UNC Workgroup Report

# UNC 0607S:

## Amendment to Gas Quality NTS Entry Specification at the St Fergus NSMP System Entry Point

**Figure 1: Connections and gas flows into NTS entry point at St Fergus**

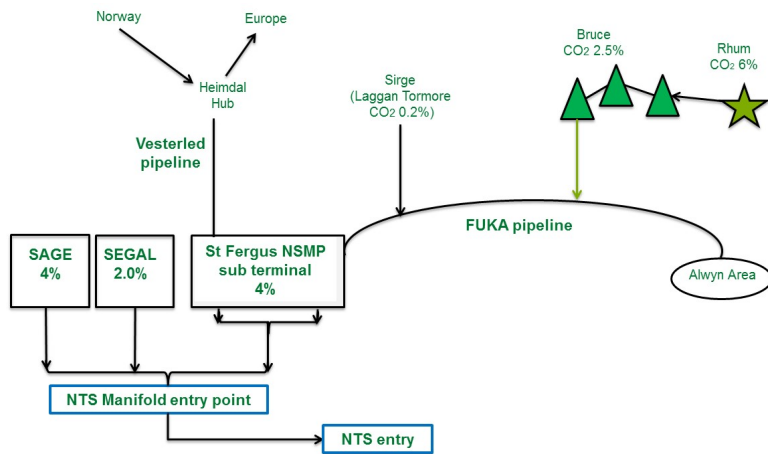
**Deleted:** Figure 11 Segal should be 2% -

(new figure provided by BP with correction, Segal now 2%)

St Fergus Sub Terminal System Entry Volumes (May 2012 to May 2016)

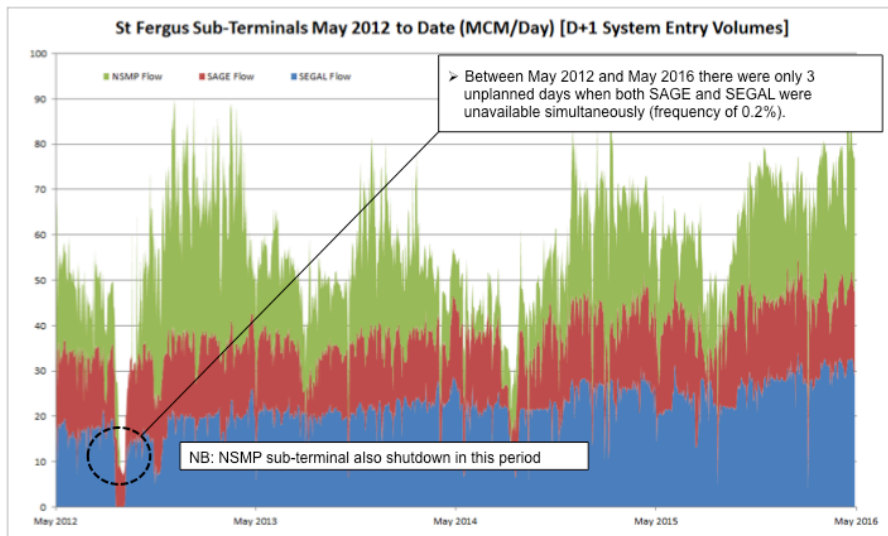
**Comment [RH18]:** Clarification from BP/NSMP

It should be noted that there were only 3 unplanned days when both SAGE and SEGAL were unavailable simultaneously (a frequency of 0.2%). Under such circumstances, consideration would be given by NSMP to shutting in Rhum flow to mitigate the risk of offspec gas. However, it should be noted that in the case noted above, the NSMP terminal was also shutdown at the same time so in this instance the issue remains moot.

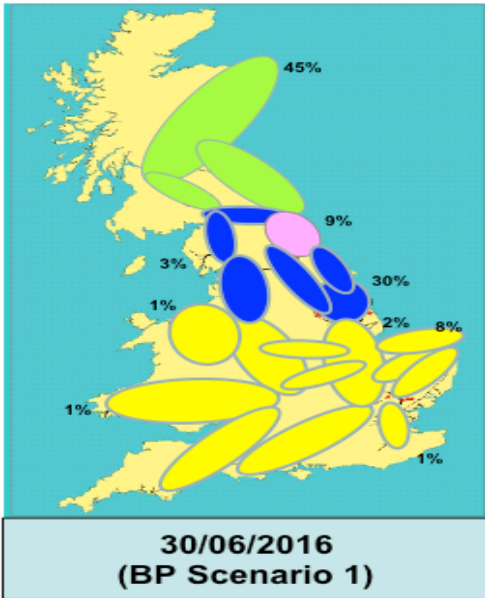
Comment [C20]: To be updated to include the weighted average CO<sub>2</sub> positions and the maximum daily CO<sub>2</sub> levels.

Comment [RH21R20]: Need to Update following 22/5/17 NTS presentation into appendix along with average daily cost from Feb 2017 WG meeting
